A/NE-PK/218

We reply to TD's comments

LAYOUT PLAN

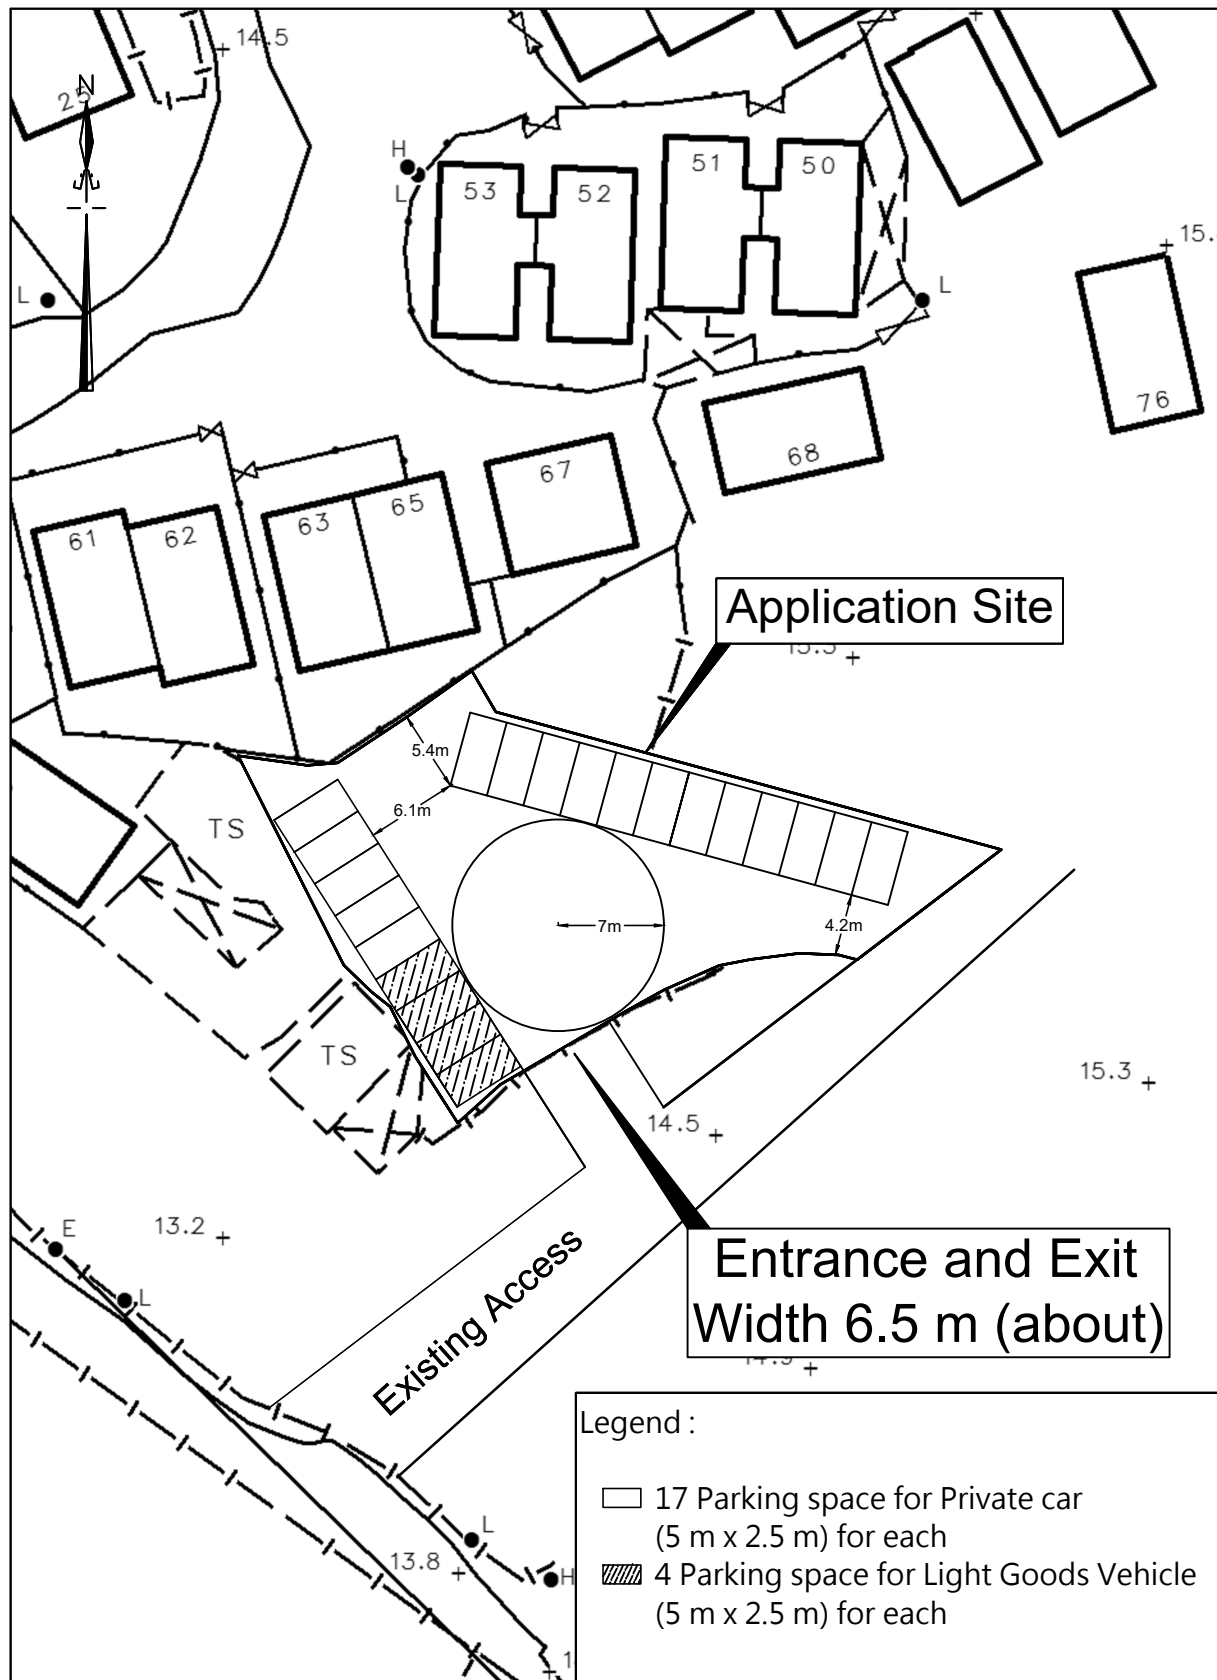
- b. Please refer to the attached layout plan for the dimensions of the driveway within the application site.
- c. The vehicle entrance to the application site is approximately 6.5 meters wide, which is sufficient for our vehicle to pass through.
